Model: Di-C1LL	Date: 01-Oct-10	No.: RD112001
----------------	-----------------	---------------

Subject: Firmware Release Note: Printer		Prepared by: M.Saiki	
From: 2nd Overseas Tech Support Sec., 2nd PQM Dept.			
Classification:	<input type="checkbox"/> Troubleshooting	<input type="checkbox"/> Part information	<input type="checkbox"/> Action required
	<input type="checkbox"/> Mechanical	<input type="checkbox"/> Electrical	<input type="checkbox"/> Service manual revision
	<input type="checkbox"/> Paper path	<input type="checkbox"/> Transmit/receive	<input type="checkbox"/> Retrofit information
	<input type="checkbox"/> Product Safety	<input checked="" type="checkbox"/> Other (Firmware)	<input checked="" type="checkbox"/> Tier 2

This RTB has been issued to announce the firmware release information for the **Printer**.

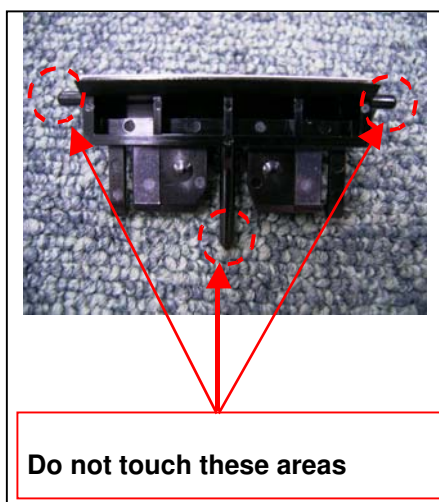
A loud vibration is heard while paper is being fed from Paper Feed Tray 1 or 2.

The friction is high between the paper and the friction pad, and a vibration is generated. This vibration is transmitted via the friction pad holder to the paper tray, where it resonates and creates a loud noise.

A quick-drying grease is applied to the paper tray (P/N D0392551) to make the contact with the paper tray more smooth.

Applied from: October 2010 production

If this symptom is reported, replace the friction pad with the following:

P/N D1052722 FRICTION PAD:SERVICE PARTS:ASS'Y

Important: When you replace the friction pad, make sure to handle the new part very carefully. Do not touch the areas shown in the photo below. This is to prevent the grease from getting on the surface of the feeding pad. If the grease sticks to the pad, a double-feed paper jam may occur.
